TECHNICAL MEMORANDUM

Reference No.
CA0036314.1956_1000_TM_01_Dec2024_Rev0

AUGUST 2024 ANNUAL GEOMECHANICAL AND GEOTECHNICAL INSPECTION, BAFFINLAND IRON MINES, PIT 1 – NULUUJAAK OPEN PIT AND WASTE ROCK STORAGE FACILITIES

Table 2: Summary of Observations for Mary River Pit 1 (Nuluujaak Open pit)

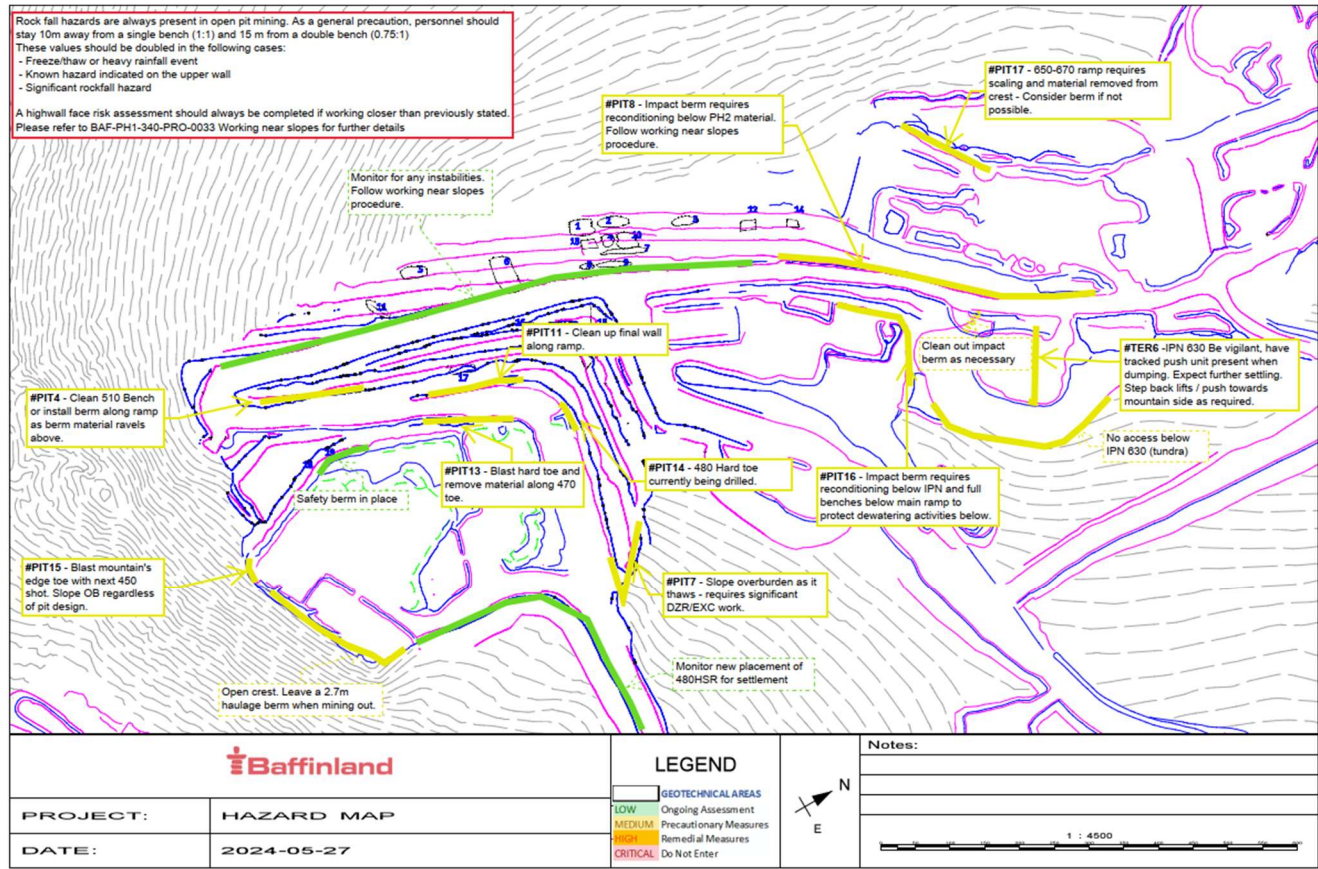
Mine Area	Observations	Recommendations
	However, review of the Phase 1 and Phase 2 pit shells provided subsequent to the site visit indicate that this possible ramp development may be well over five years in the future. This ramp development is not part of the Phase 1 or Phase 2 designs. Existing overburden slopes are sitting at 36°.	<ul style="list-style-type: none">○ Observations will help understand if a ramp in overburden will be prone to erosion.○

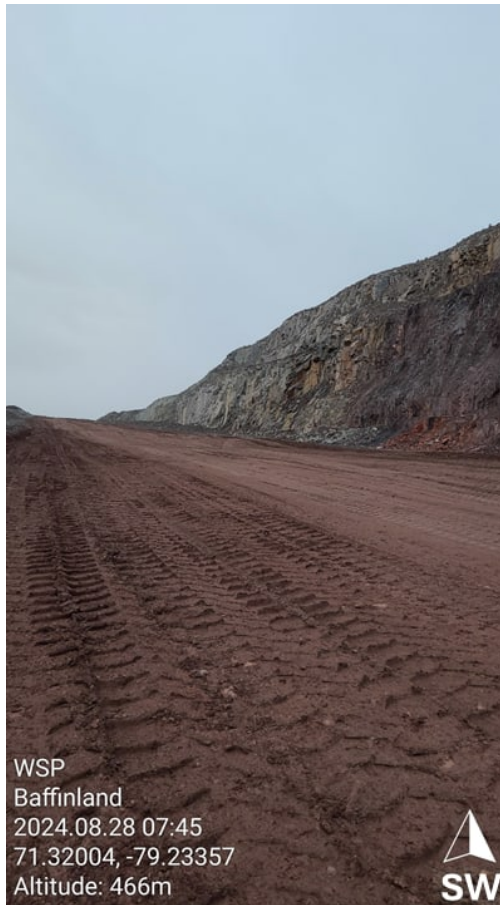
Monitoring:
Visual.

Instrumentation:
- no prisms
- no radar
- no inclinometers.

Does Deposit 1 need prisms as a second source of information on long-term deformation?

Marc to follow-up on this. Is InSar the right option in this context? Is Baffinland already collecting InSar data incidentally?

Of what value are prisms in the short or long term, this open pit geotechnical setting?

We might want inclinometers in the planned OB ramp.

Photo 40

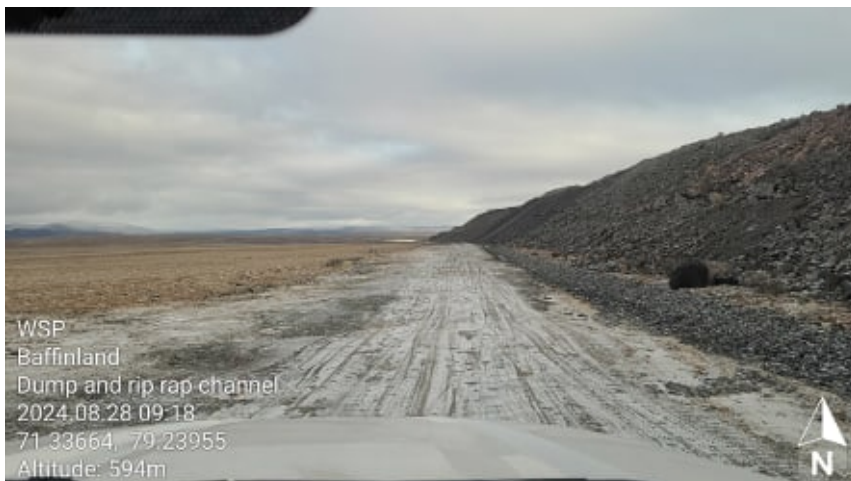
Waste rock dump and perimeter ditch.

Ditch is rip rapped.

Apparent dip of the waste rock slope is 32 degrees.
